SERVICE **TEK** NOTES

TABLE OF CONTENTS

Change Reference: C6-1088Product: 1730/1731 OPT 16Manual Part No: 070-4474-02**ELECTRICAL PARTS LIST AND SCHEMATICS CHANGES****CHANGE TO READ:**

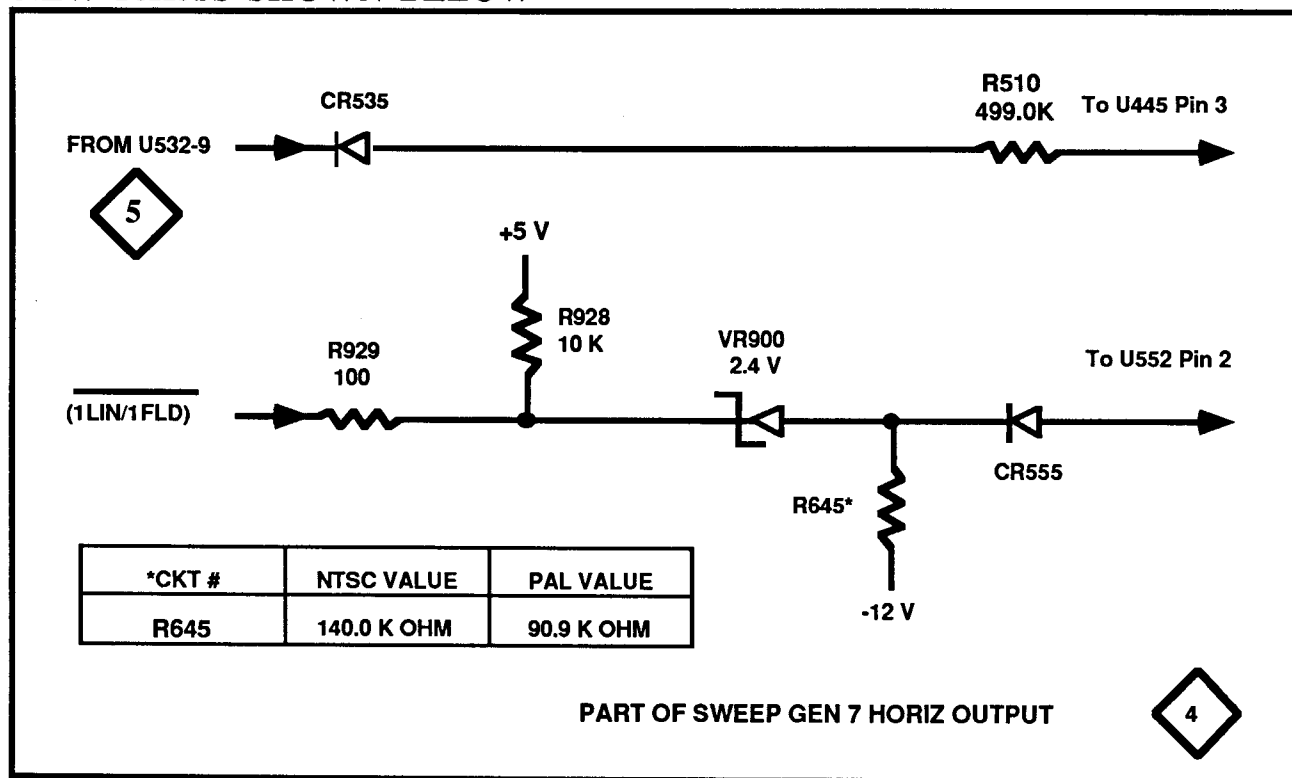
ADD:
